Addendum #2

Date: June 7, 2022
From: Cynthia McCanna, Procurement Strategist
To: Interested Bidders
Subject: Addendum # 2 Solicitation #22-7995 - 98th & 99th Avenue North Public Utilities Renewal Project

STORAGE LOT DRIVEWAY DETAIL
N.T.S.

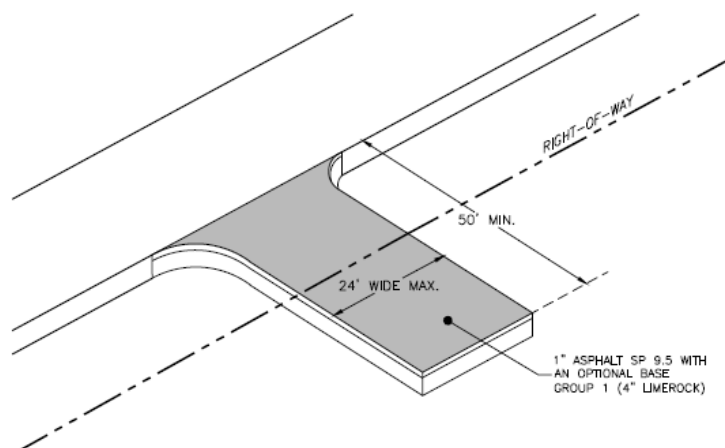
1. The following language has been added to Exhibit J Technical Specifications, Section IV Special Project Provisions, Item #40:

Storage lots shall meet the following requirements:

- a. 24' wide temporary asphalt driveway from the EOP to at least 50' into the property;
 - Asphalt driveway shall be 1" of SP 9.5 with Optional Base Group 1 (4" of limerock). The contractor shall maintain the temporary surface in good condition throughout the duration of the project.
 - b. 6' tall chain link fence installed around the entire staging area with:
 - 5' setback from side and rear property lines (no setback required at ROW line)
 - Green wind barrier on all sides, including front and gate;
 - c. No after hour access. All materials for work between 7pm and 7am shall be delivered to the work site between 7am and 7pm, except for emergency work.
2. The "Storage Lot Driveway Detail" below, consistent with the storage lot language above, will be incorporated in the conformed construction plans.
